P0728-C700-14-2110

September 12, 2014

**Subject: SVBX Design Build Contract DB11002F  
Silicon Valley Berryessa Extension Project C700  
General Order 95 Fencing Variance Request**

LINE, TRACK, STATIONS AND SYSTEMS  
 DESIGN UNIT 012  
 PIPER DRIVE  
 LAYOUT PLAN  
 PR2 9+00 TO PR2 14+00

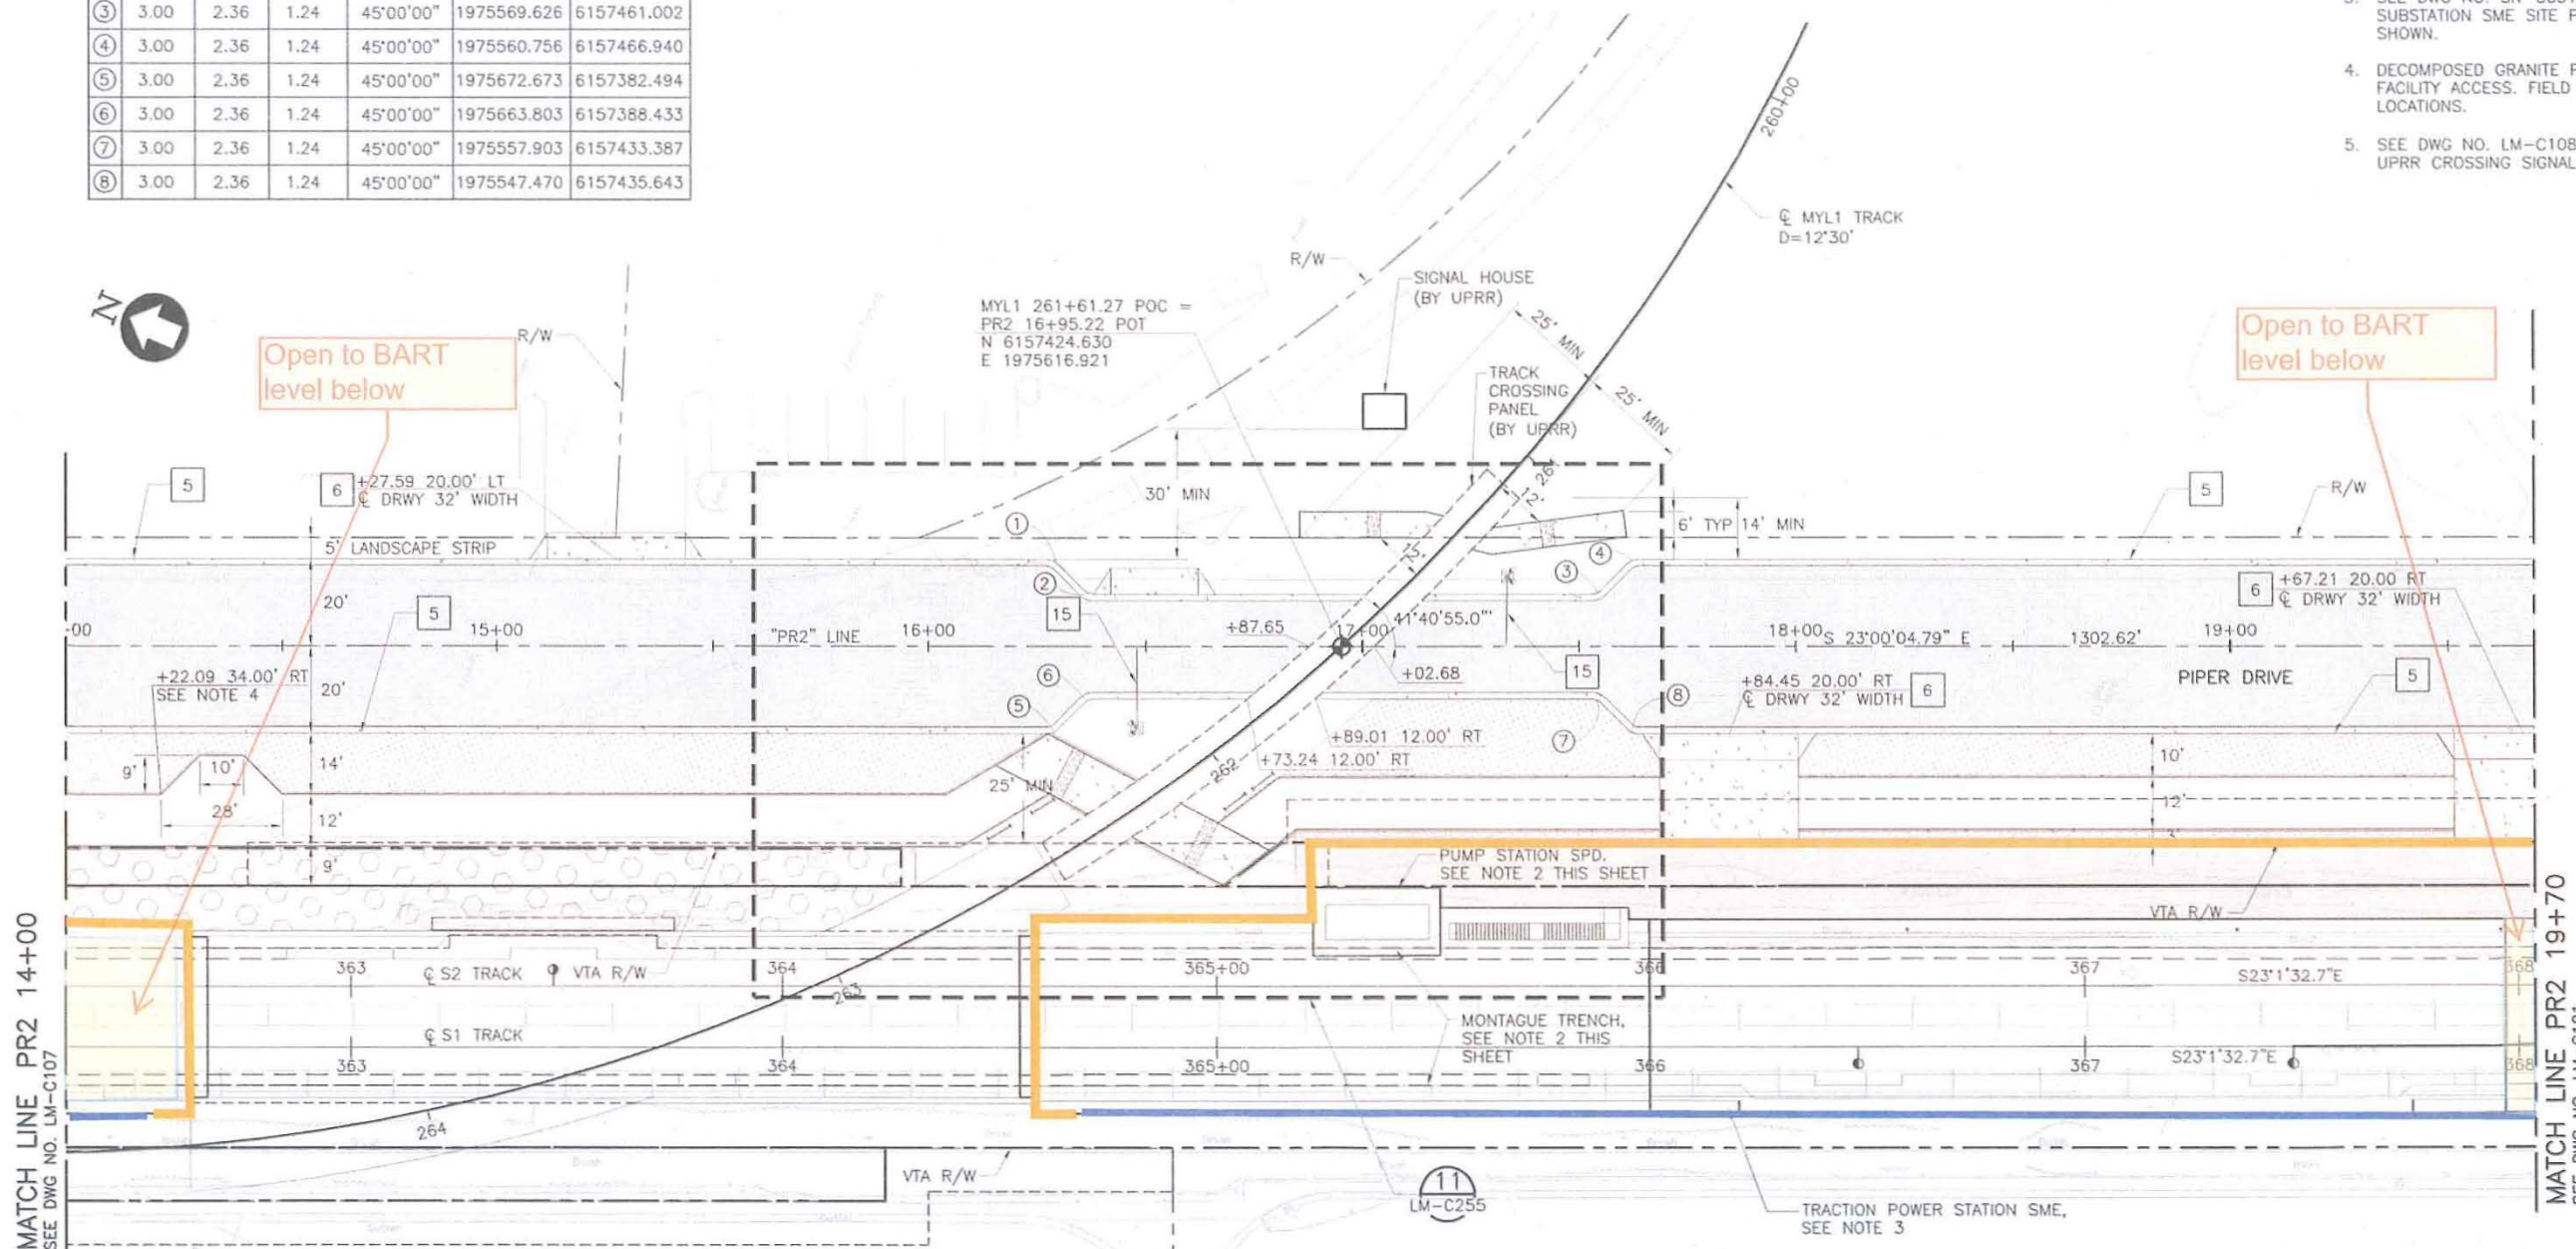
On the east side of the BART corridor along Piper Dr., VTA intends to install an alternative ornamental picket fence (see attached FSK02) with the features listed below. The limits of the ornamental picket fence are shown on attached sheets C107, C108 and C101.

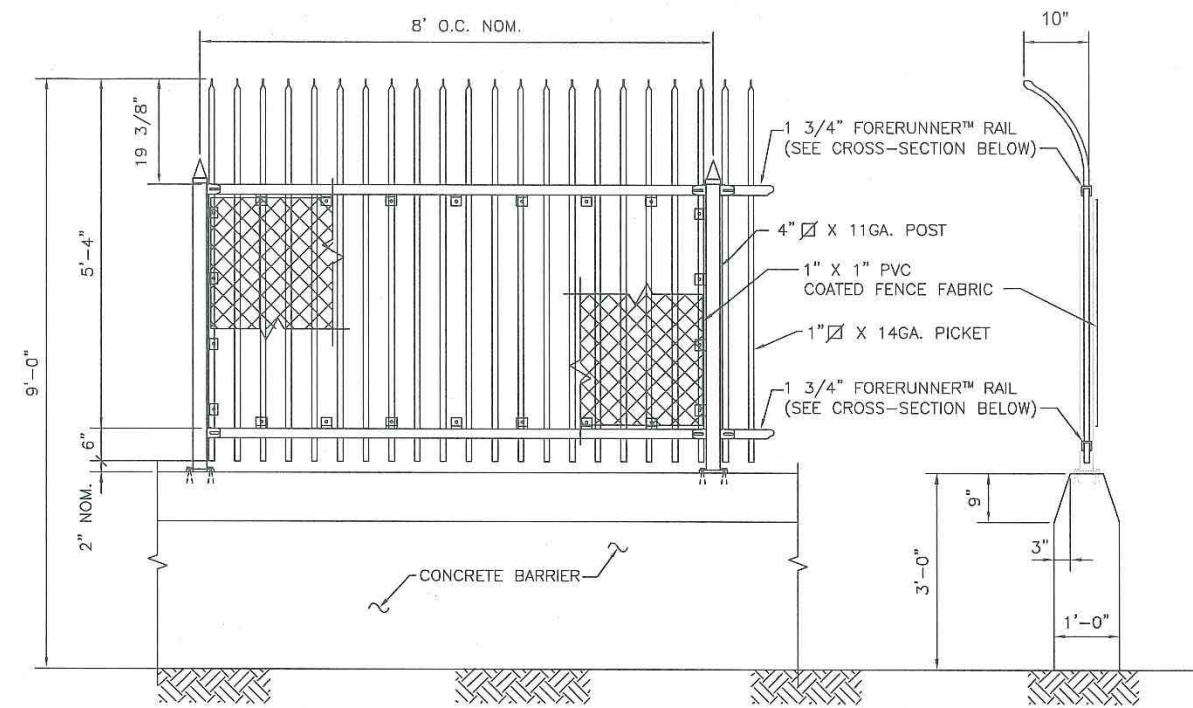
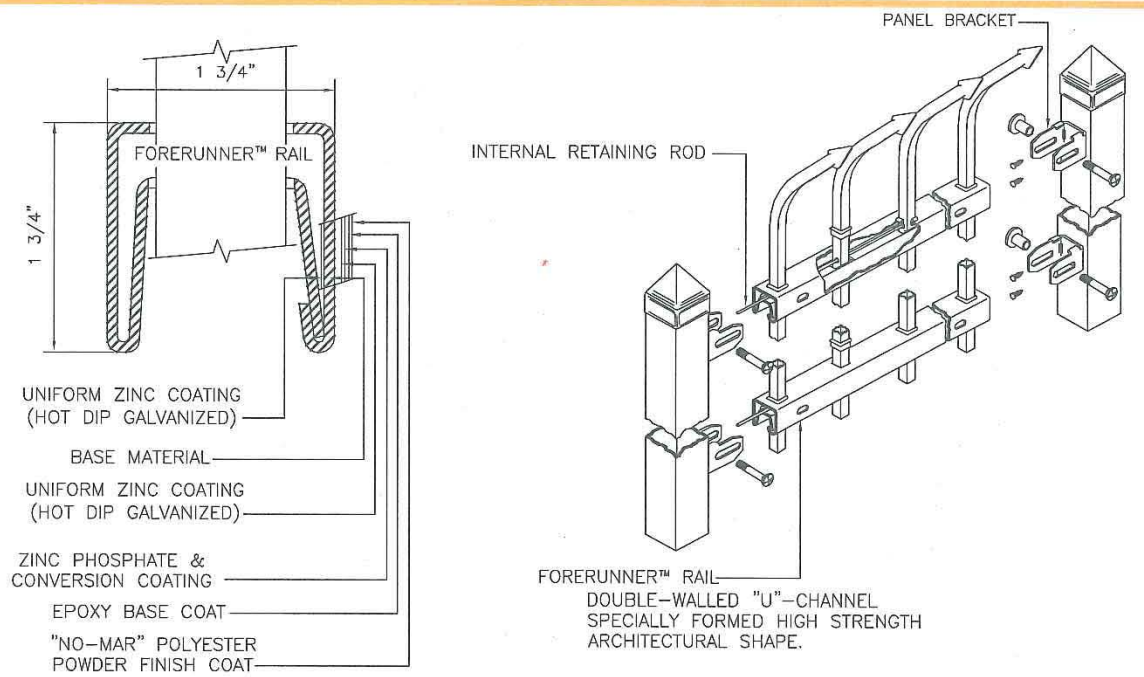
- Painted steel square post with pointed top spaced at approximately eight feet.
- Painted steel pickets that will extend from walking surface to achieve a total fence height (with or without concrete barrier) of nine feet above walking surface.
- The top 19 inches of the pickets will be inclined away from BART corridor projecting 10 inches horizontally at approximately 27 degrees from vertical. Top end of the pickets will be pointed as shown on FSK-02.
- A coated steel wire fabric with openings approximately one inch by one inch will be fastened to the fence.
